## PLANNING & LICENSING COMMITTEE

### ADDENDUM REPORT

Report no.	Item no.	Application no.	Applicant	Parish
137/2022	1	2022/0469/FUL	MS J DODMAN	LANGHAM

Figure 46: 25 degree thumb rule. Section in plane perpendicular to the main face of the building.

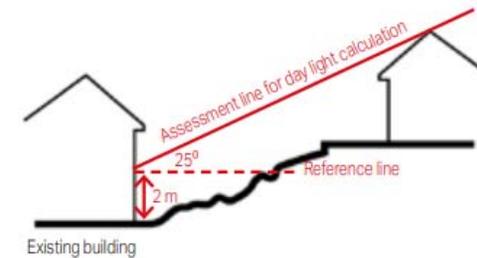
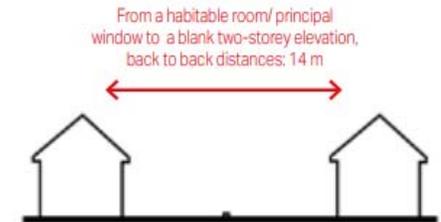
"I as ward member have been contacted by the applicant and a neighbour, there have been issues that Justin Johnson will address either prior or at the meeting regarding the use of out of date maps, and the reality of the size of the extension in relation to the neighbouring houses, Langham parish Council have commented on this, I would urge all of you to give careful consideration to such things as the 25 Degree test:

"If a new building or extension breaches a perpendicular line at an angle of 25 degrees above the horizontal taken from a point 2 metres above ground level on an existing house, it is likely that windows in the existing house will be overshadowed."

This test is clearly aimed at the rural development communities and we should consider this as part of the decision making process?

The above sets out how the Council will use a 45 degree rule to assess the impacts of developments on adjacent properties. The 25 degree rule is not relevant in this instance.
